INDESIT company

Model type:
AVD127EX

Commercial code:
F029768

Fig . 001

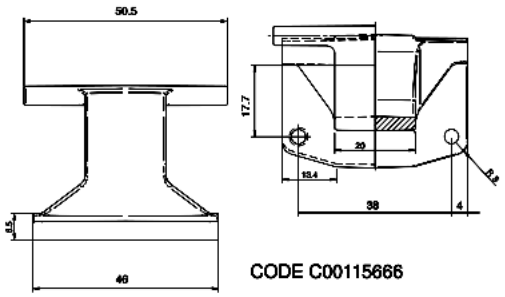
n1040349: Introduction of 150° Zamac hinge on Ariston 46 models.

From serial no. 50207.0001, all Ariston models produced in the Teverola factory (see table 001 attached) with industrial code (given on the rating plate) starting with 46, have been equipped with a Zamac hinge with 150° opening angle, code C00115666

(see Fig.001).
This modification has involved the introduction of the following items:

Code C00115670 - Complete door EVOII 150° white 27 with standard glass;
Code C00115674 - Complete door EVOII 150° white 27 with long glass;
Code C00115667 - EVOII body for 150° hinge white 27;

The premodified items are not interchangeable separately with the modified ones.

Code C00110133 - Complete door EVOII Standard 180° white 27 standard glass;
Code C00092157 - Complete door EVOII 180° white 27 long glass;
Code C00096193 - EVOII body for 150° hinge white 27;
